**RE: Lands of Joe Grady
3815 Pedroncelli Rd. NW
Grading & Drainage Plan
Engineer's Stamp Date: 04/02/2025
Hydrology File: F13D038
Case # HYDR-2025-00095**

TITLE: GRADING PLAN
LANDS OF JOE GRADY

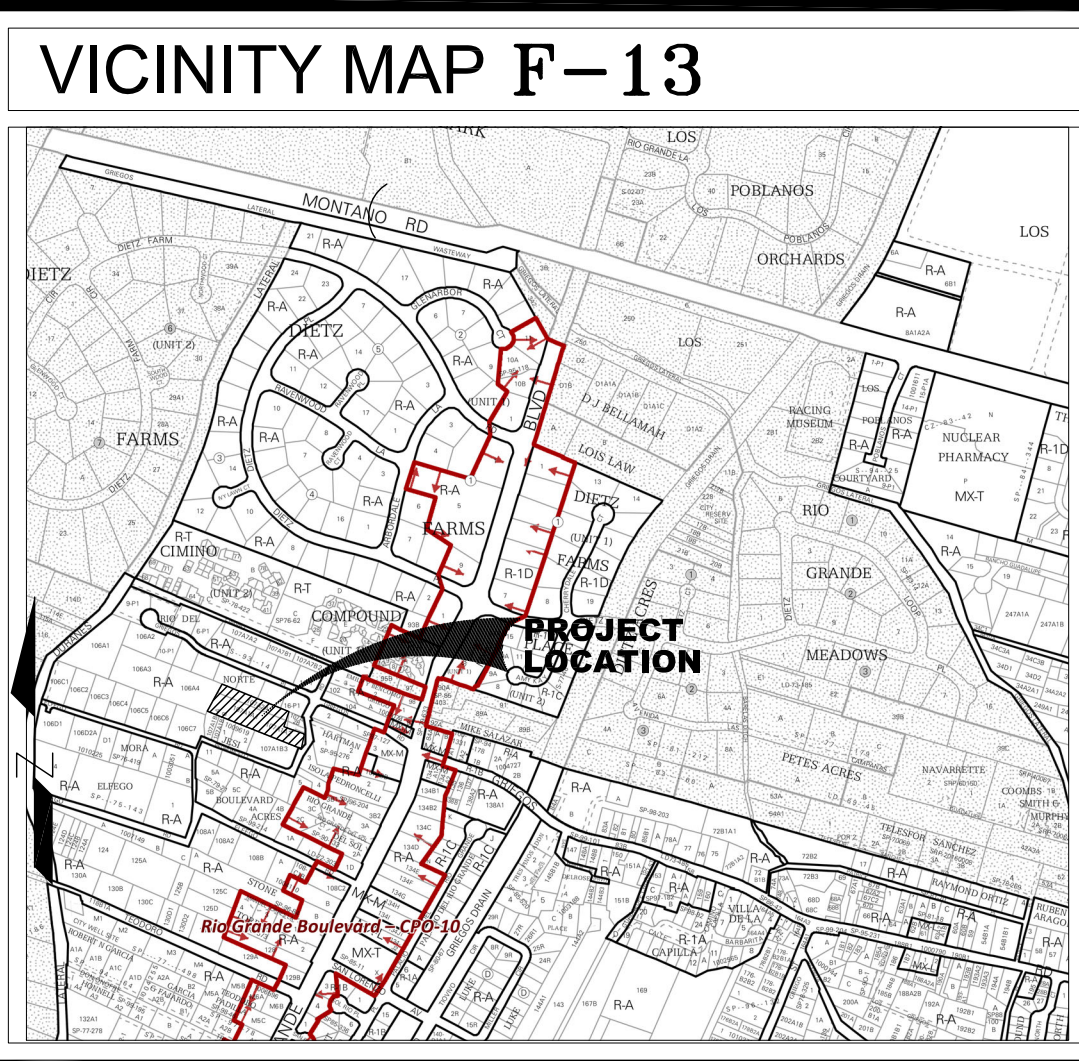
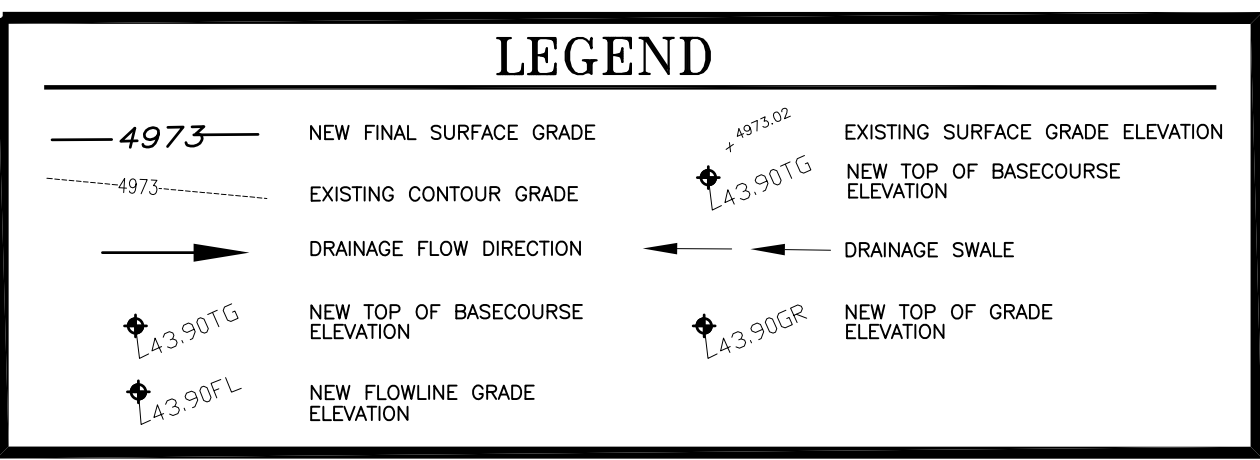
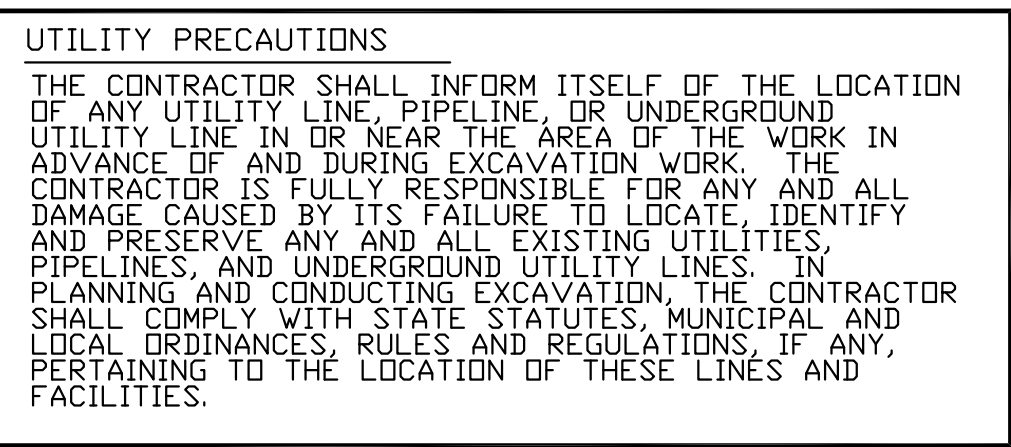
Based upon the information provided in your submittal received 04/02/2025, the Grading & Drainage Plan is approved for Grading Permit, Building Permit, or action by the DFT/DHO for platting action. Please attach a copy of this approved plan in the construction sets for Building Permit processing along with a copy of this letter.

1. Engineer's Certification, per the DPM Part 6-14 (F): *Engineer's Certification Checklist For Non-Subdivision* is required.
2. Please provide the Drainage Covenant with Exhibit A for the stormwater quality ponds per Article 6-15(C) of the DPM prior to Permanent Release of Occupancy. Please submit the original copies along with the **\$ 25.00** recording fee check made payable to Bernalillo County to the Hydrology Section of Development Review Services on the Ground floor of Plaza de Sol.
